Contract #: 04-0120F4Cty: SF/ALA Rte: 80 PM: 13.2/13.9File #: 69.25B**QUALITY ASSURANCE -- NON-CONFORMANCE REPORT****Location:** Changxing Island, Shanghai, PRC**Report No:** NCR-000272**Prime Contractor:** American Bridge/Fluor Enterprises, a JV**Date:** 08-May-2009**Submitting Contractor:** Zhenhua Port Machinery Company, Ltd (ZPMC), Changxing Island**NCR #:** ZPMC-0246**Type of problem:**

Reference Description: Welding With Incorrect Electrode, Welds: SEG001A-23, 24, 25 & 27**Description of Non-Conformance:**

Dear: Mr. Charles Kanapicki
Job Name: SAS Superstructure

Subject: NCR No. ZPMC-0246

Draft of welding discontinuity:

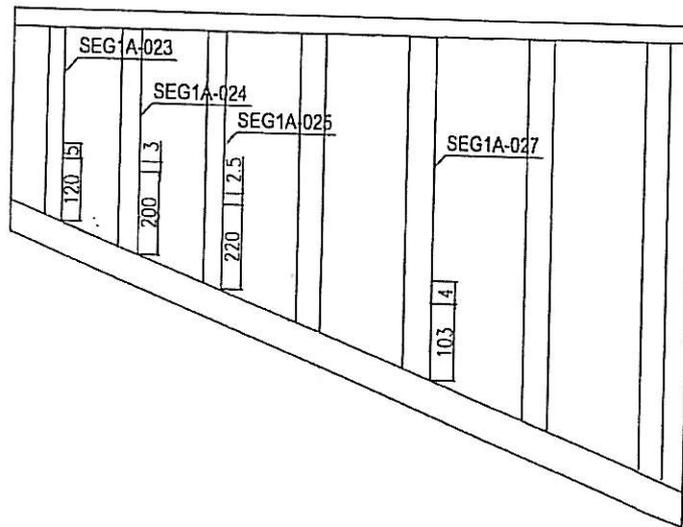
胡国兴施工队1AAW, SEG1A-023, 长度为5mm, SEG1A-024, 长度3mm, SEG1A-025, 长度为2.5mm, SEG1A-027, 长度为4mm返修时按板材应用THJ506Fe-1, 实际错用的TL-508.

1AAW fabricated by work team: Hu Guoxing, the weld metal was error used as TL-508, which shall be THJ506Fe-1, 5mm in length on weld SEG1A-023, 3mm in length on weld SEG1A-024, 2.5m on weld SEG1A-025.

1. 将补焊材质用错的区域采用碳刨、打磨的方法去除补焊材质用错的区域, 碳刨前根据相应返修WPS进行预热;
2. 准备好正确的接头型式, 具体参照返修WPS;
3. 将碳刨区域打磨光滑;
4. 根据批准的返修焊接工艺规程(WPS)进行预热及焊接;
5. 将焊缝打磨使与邻近焊缝平齐;
6. 根据批准的车间图纸要求对焊缝检查;

1. Gouge or grind the area where the weld metal was error used as TL-508. Preheat prior to gouging according to the relevant WPS.
2. Prepare excavation according to the relevant repair WPS.
3. Grind the gouged area smoothly;
4. Preheat and weld according to the relevant repair WPS.
5. Grind the weld flush with the adjacent weld.
6. Perform NDT according to the working drawings.
